# Access Compliance Report

## Public Rights-of-Way (Curb Ramps)

Intersection ID: 53746	Main Street: SPRINGWOOD_ESTATE_DR	Cross Street: CANTERBURY_CASTLE_DR	Location: SW
ADA ID: 4AE6810F3AA6	Ramp Type: Perp	Initial Pass/Fail: Fail	Overall Compliance: No
Codes/Mitigation Info/Possible Solution			Severity Score: 25
			Field Measurements/Component Compliance

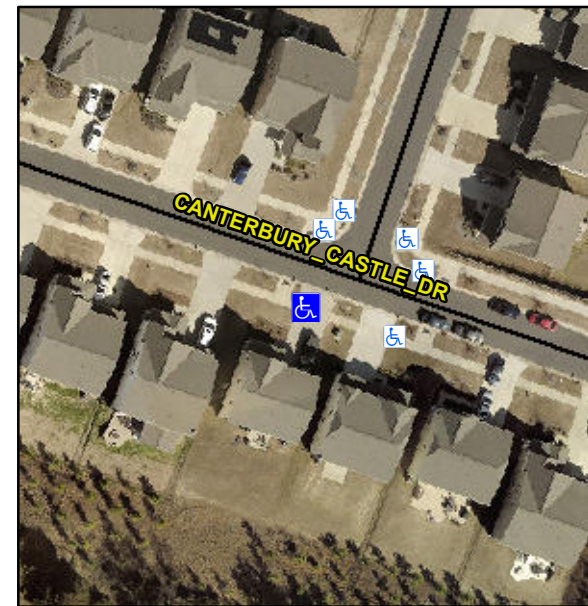
**R304.5.3**

Compliance	Description	Data	Compliance	Description	Data
N/A	Ramp Length (in)	96.0	Yes	Ramp Slope (%)	6.5
Yes	Ramp Width (in)	48.0	No	Ramp XSlope (%)	8.0
N/A	Flare Type LT	N/A	N/A	Flare Type RT	N/A
N/A	Flare Slope LT (%)	N/A	N/A	Flare Slope RT (%)	N/A
N/A	Flare Traversable LT?	N/A	N/A	Flare Traversable RT?	N/A
N/A	Landing Length (in)	N/A	N/A	DWS Provided?	N/A
N/A	Landing Width (in)	N/A	N/A	DWS Contrast?	N/A
N/A	Landing Slope (%)	N/A	N/A	DWS Length (in)	N/A
N/A	Landing X Slope (%)	N/A	N/A	DWS Full Width?	N/A
N/A	Landing Curb? (Y/N)	N/A	N/A	DWS Offset (in)	N/A
N/A	Shared Landing?	N/A			
N/A	Gutter Ponding?	N/A	N/A	Gutter Slope (%)	N/A
N/A	Gutter Lip Ht (in)	N/A	N/A	Gutter X Slope (%)	N/A
N/A	Painted X Walk1?	No	N/A	Painted X Walk2?	N/A
	X Walk 1 Direction	To NE		X Walk 2 Direction	N/A
N/A	X Walk 1 Width (in)	N/A	N/A	X Walk 2 Width (in)	N/A
	X Walk 1 Slope (%)	1.8		X Walk 2 Slope (%)	N/A
	X Walk 1 X Slope (%)	3.8		X Walk 2 X Slope (%)	N/A

**Remove & Replace Entire Ramp.**
